Elevation QC Report

Project: California_Central_Coast_Lidar_2011

Contractor: Digital Mapping INC.

Reviewer: Eric Jaramillo

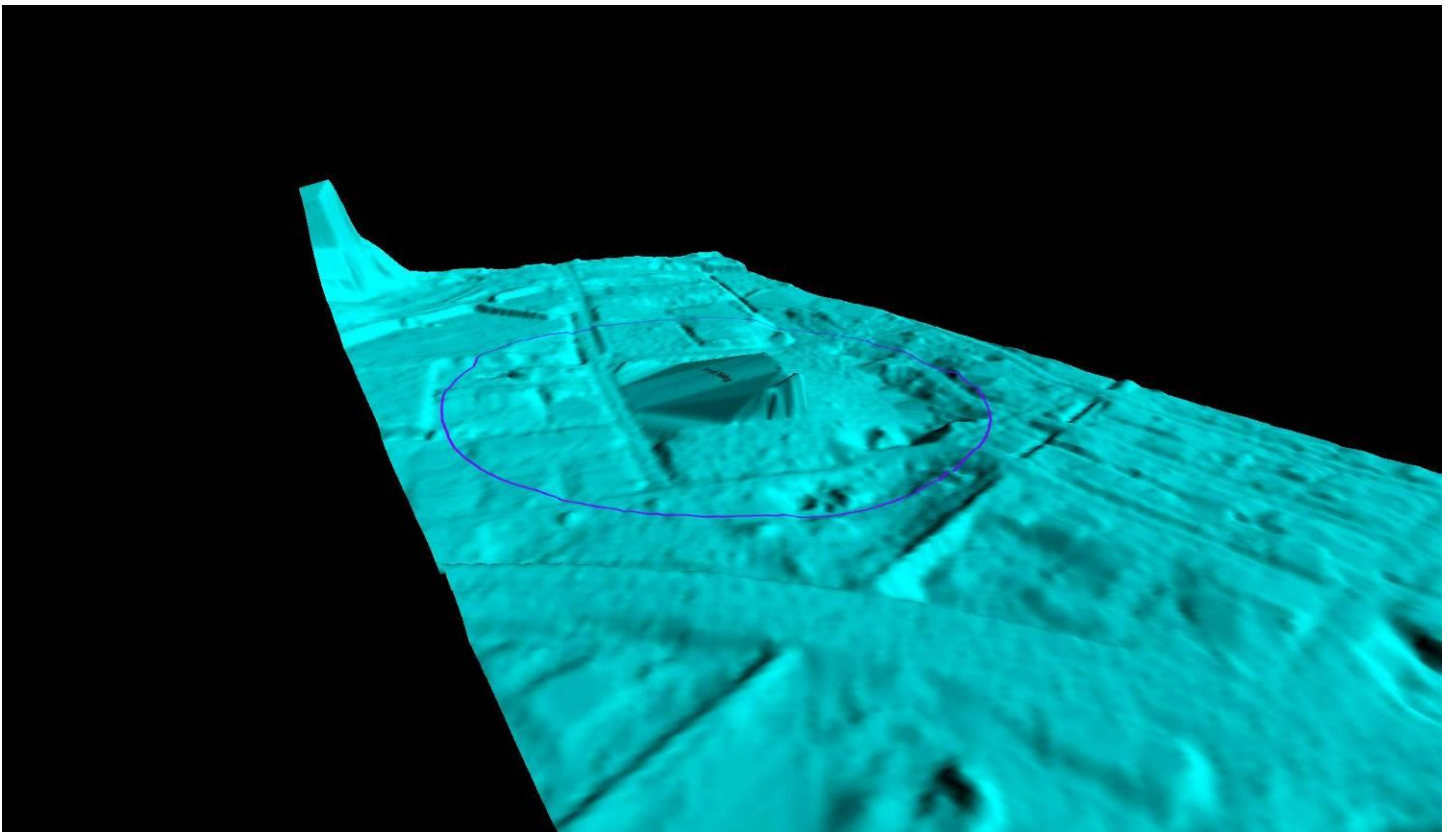
Level building Fixed

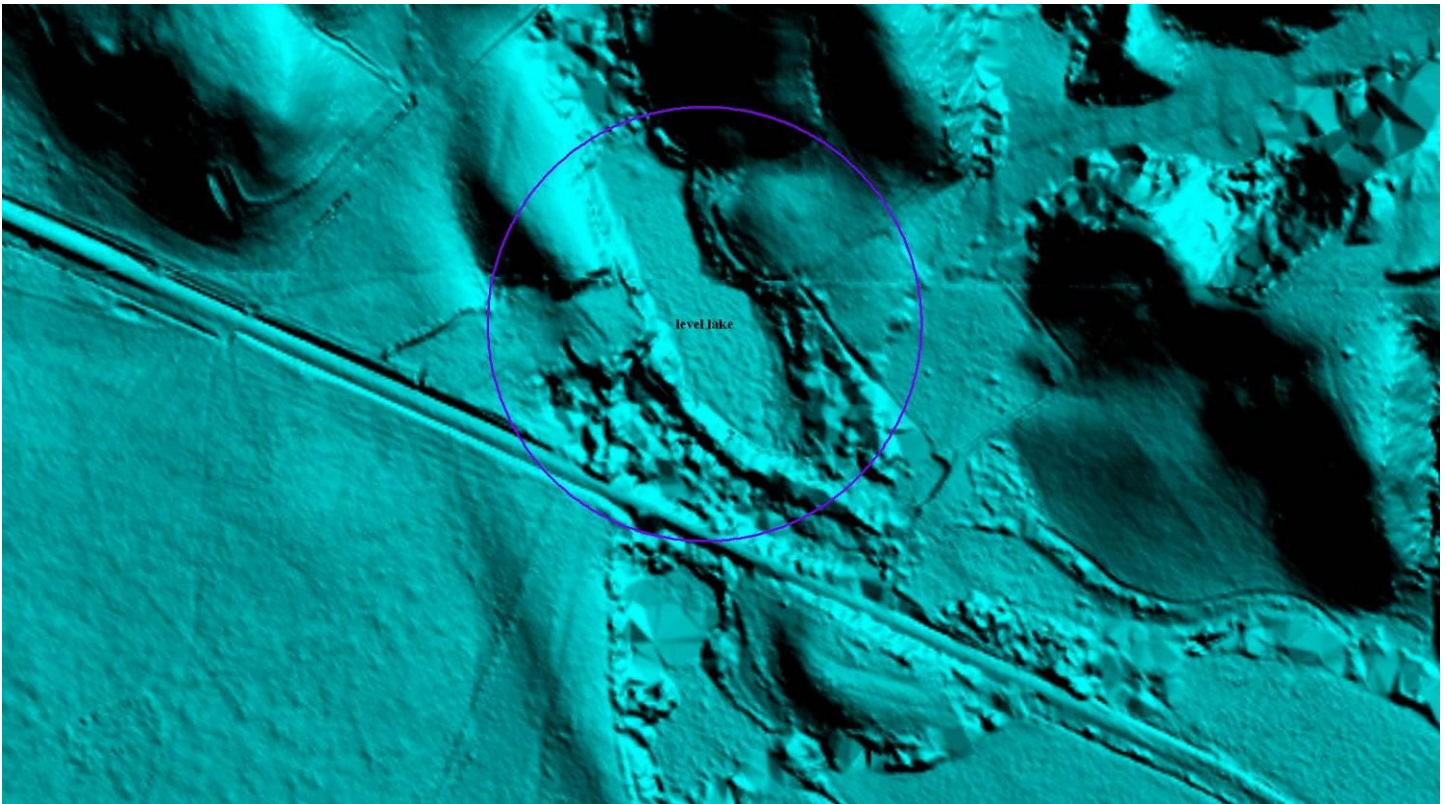
Level Lake 1 Fixed

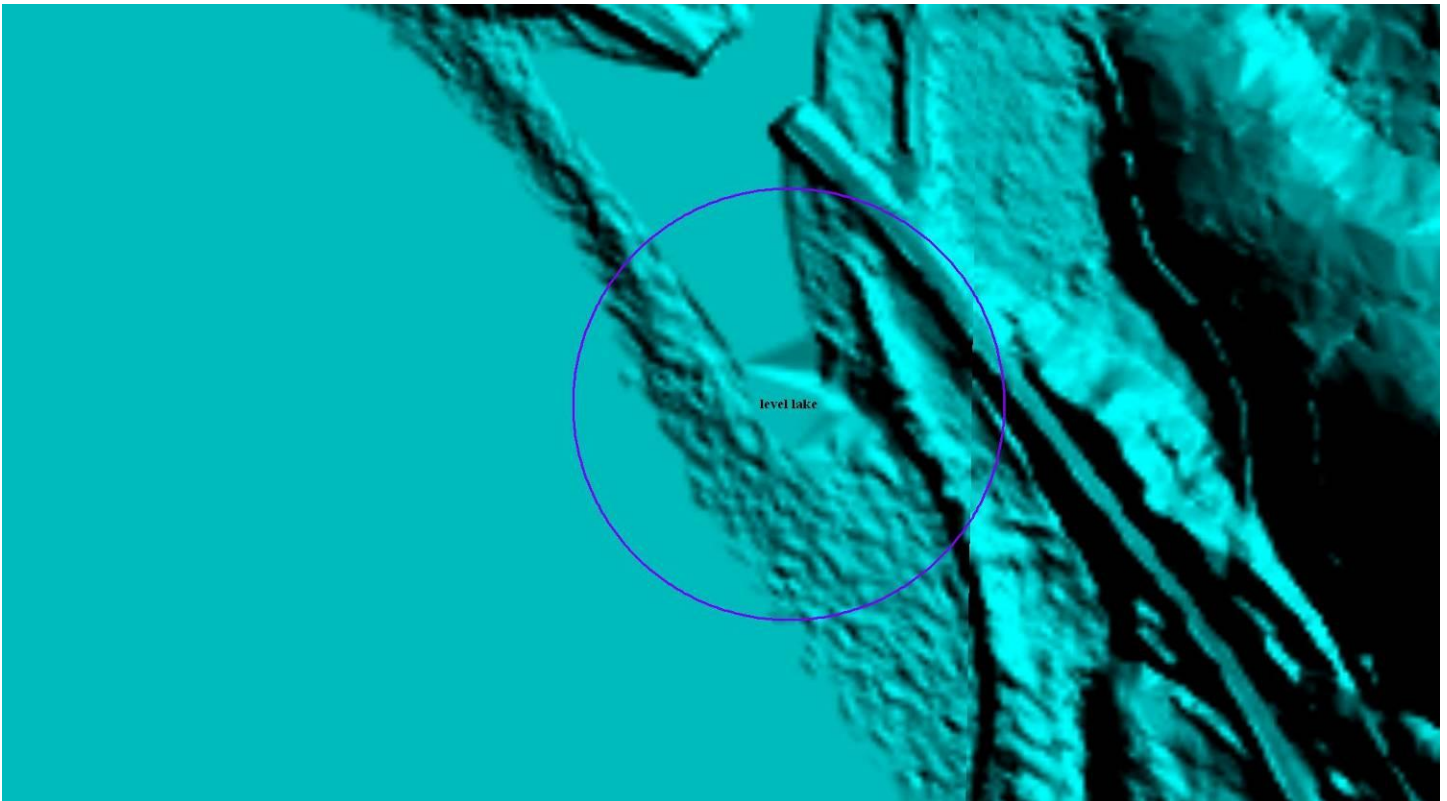
Level Lake 2 Fixed

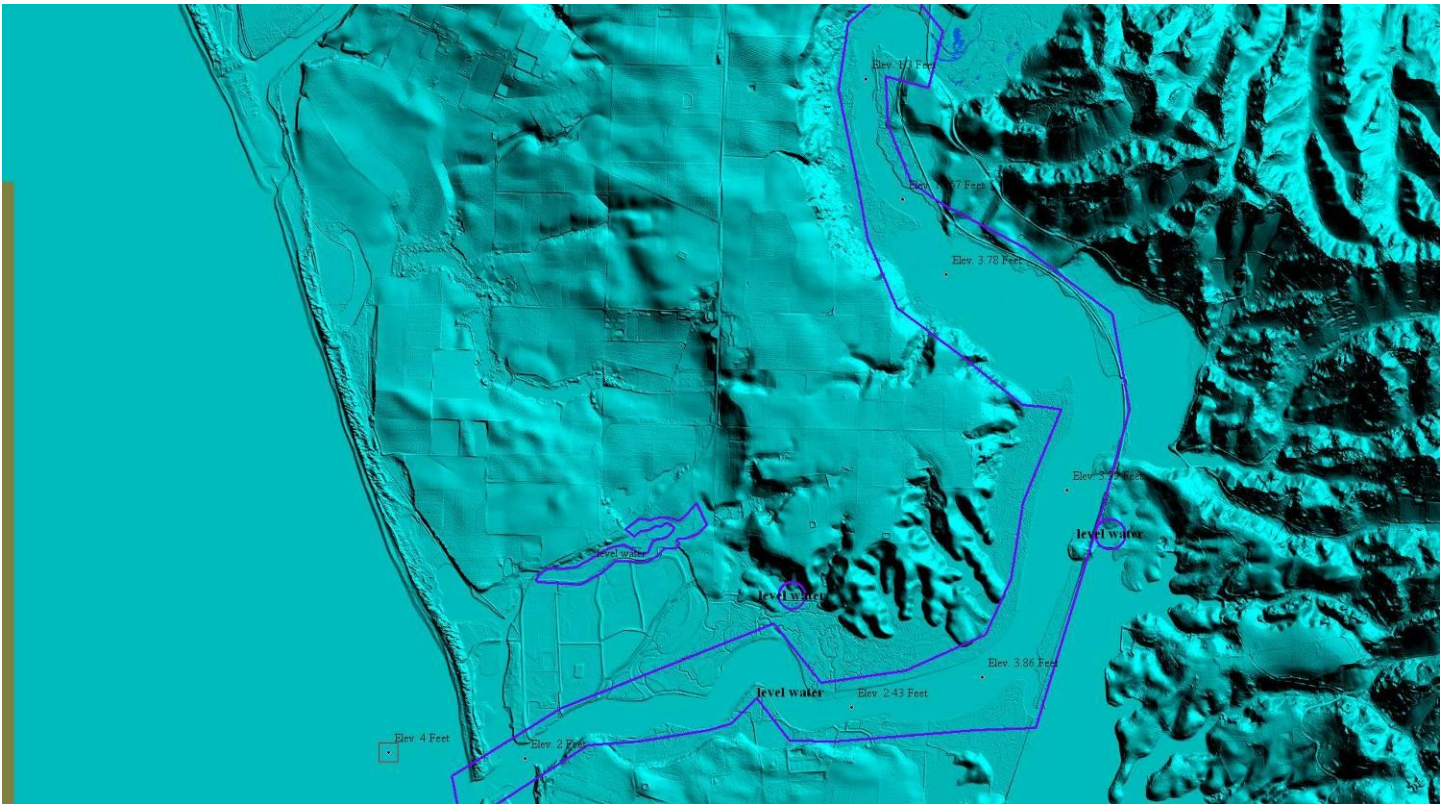
Water elevation error 1 (coast is at 4' then inland to 2', 2.43', 3.86', 3.99', 3.78', 1.3' not fixed could be high and low tide)

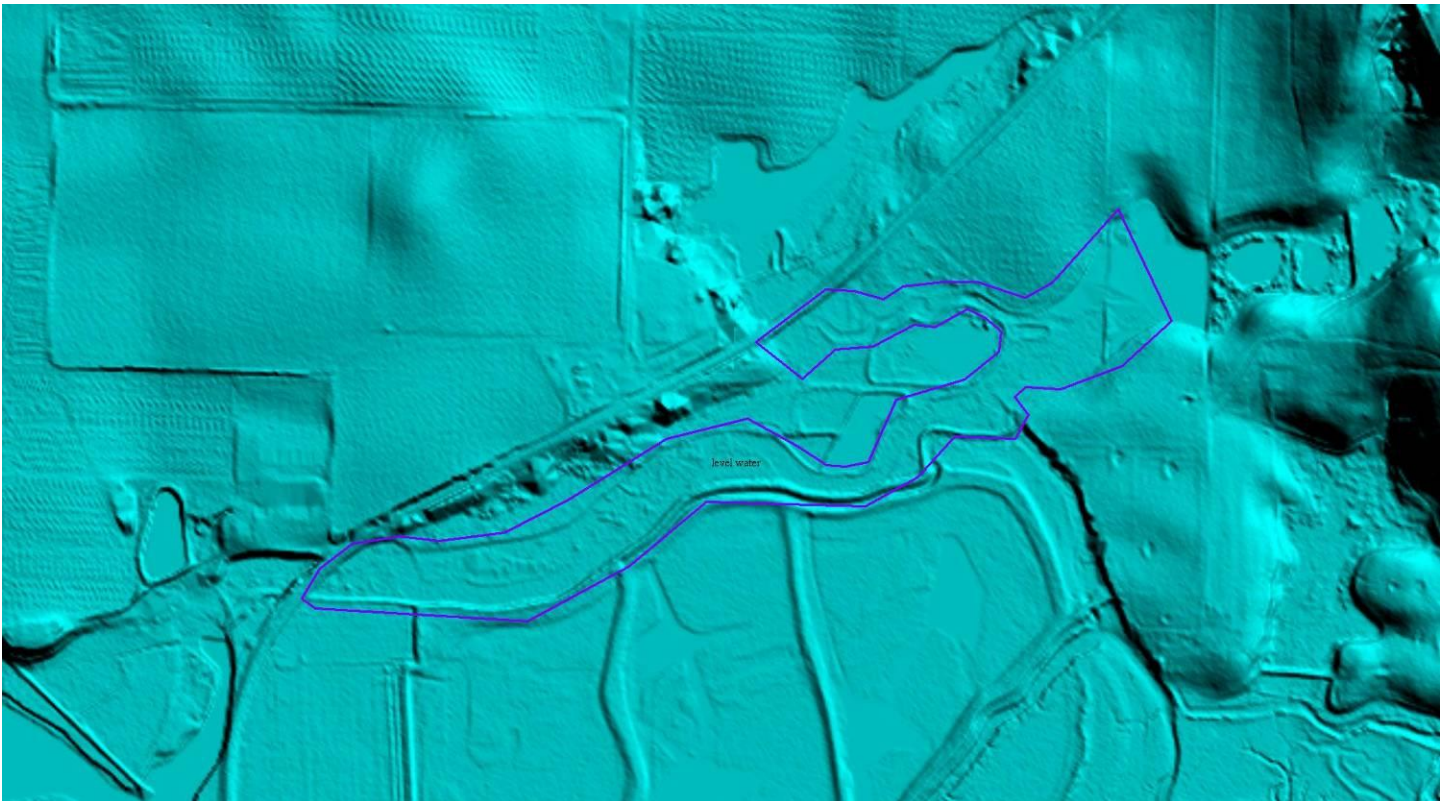
Water elevation error 2 Fixed

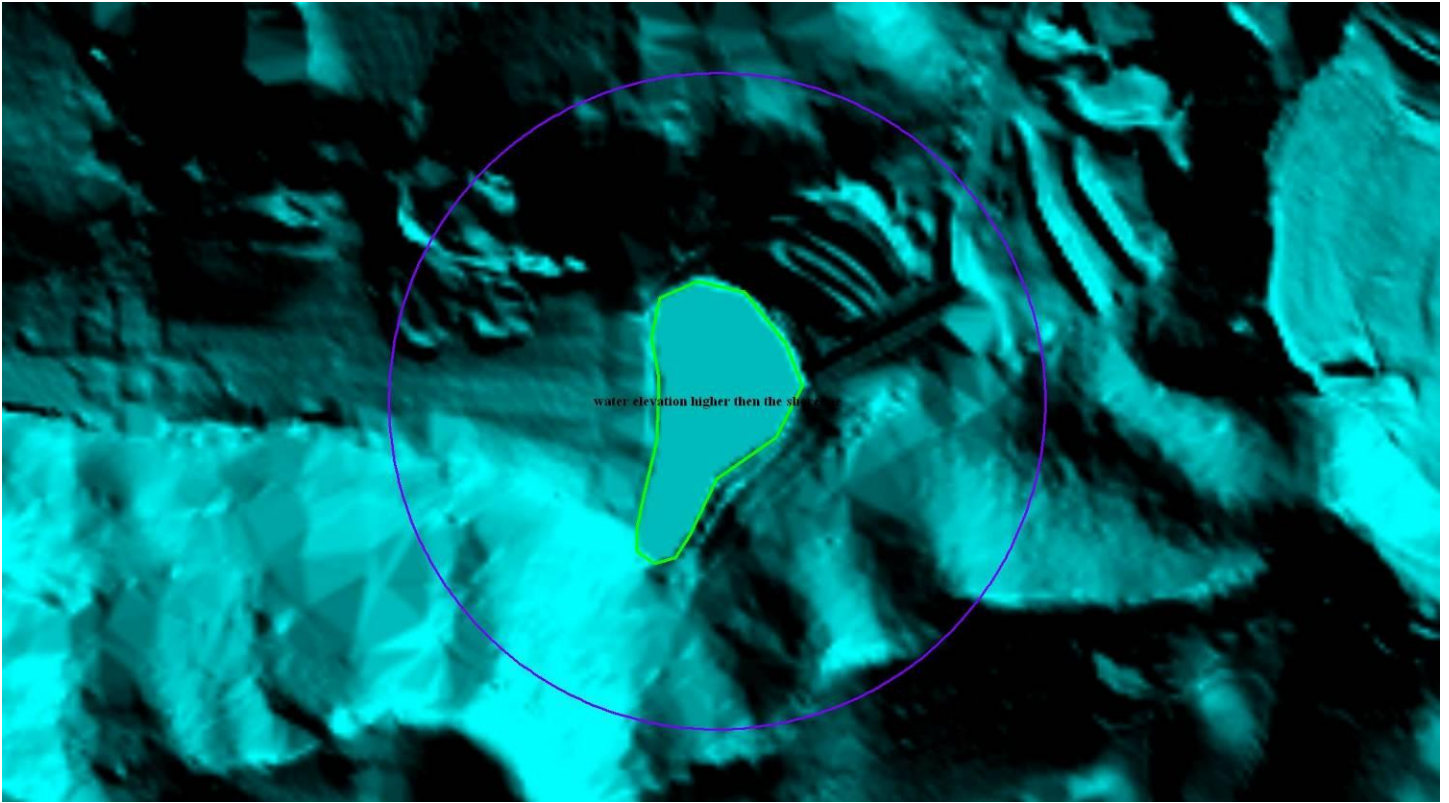
Water elevation higher then the shoreline 1 Fixed

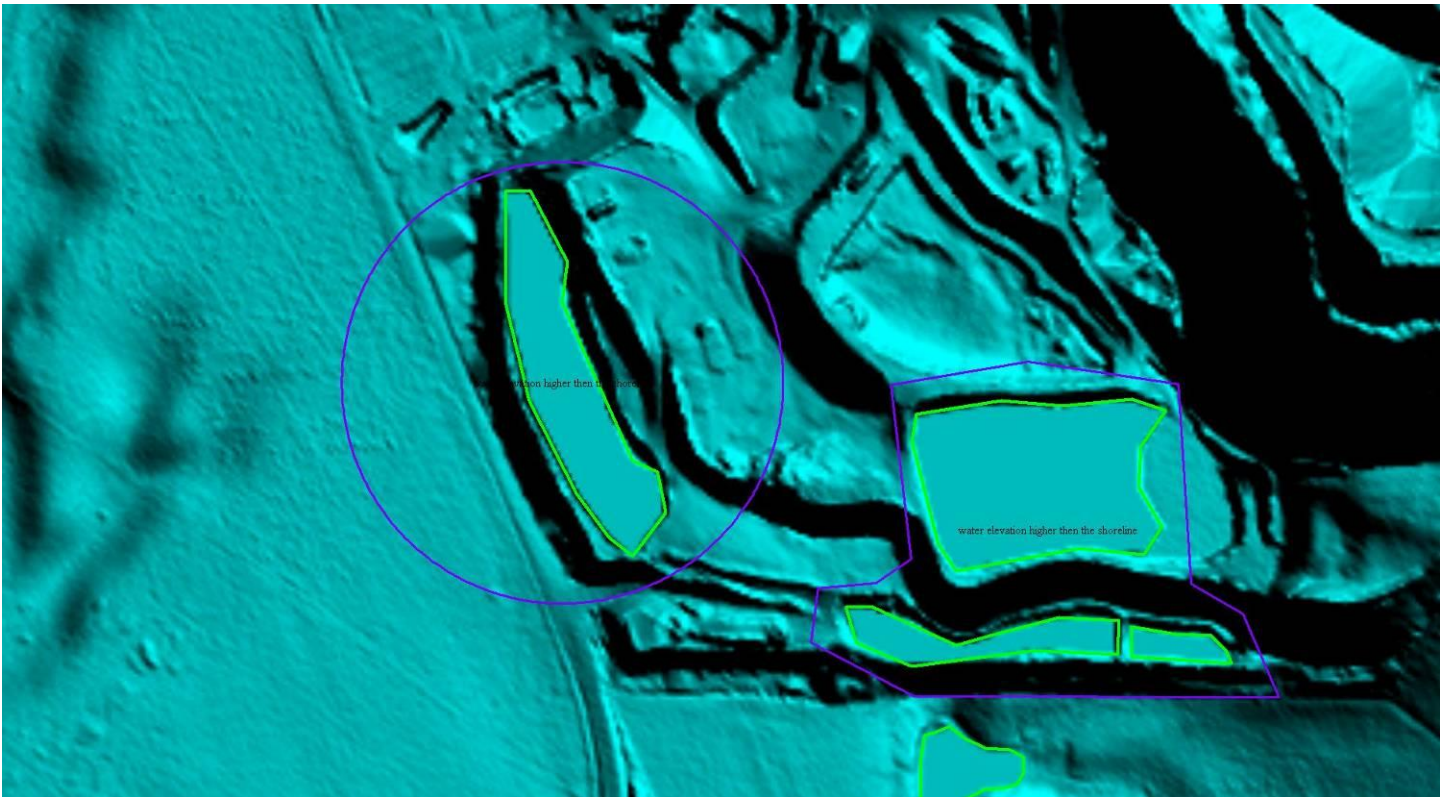
Water elevation higher then the shoreline 2 Fixed
